SB, Motor mix-up, K7000/K6500 Family, 2021-10

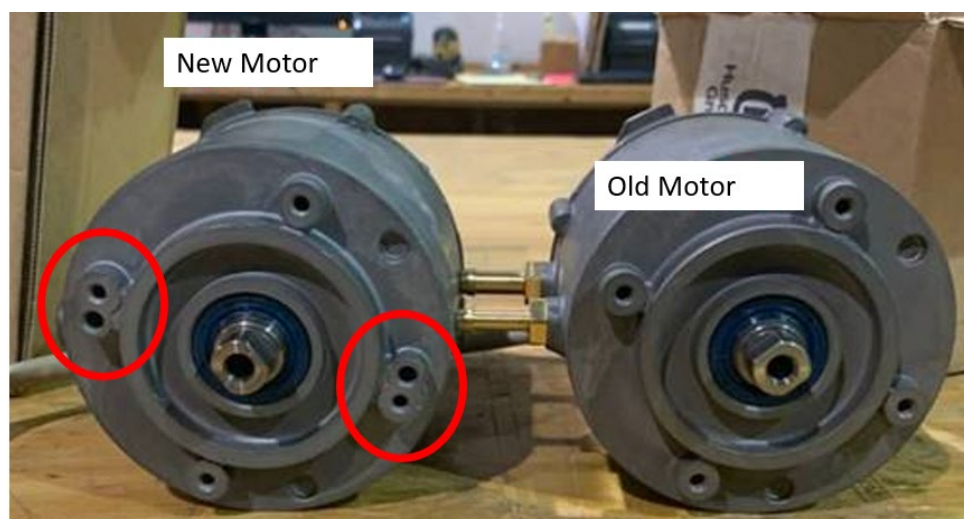
In the progress of updating the motors and cutter arms for a better fit, there has been a mix-up of motors for the K7000 and K6500 family. New motors have been stored together with old motors. The new motors are not possible to install on older machines, without changing the cutter arm. We are working on a solution where the motor is kitted with the respective cutter arm.

If you need to change a motor on a K6500 or K7000, please look at the picture below. If you have the new motor, please order a new cutter arm according to "Parts information" below.

Part name	Article no.
Cutter arm - Standard	525339402
Cutter arm - RING	581125102
Cutter arm - CHAIN	588576203
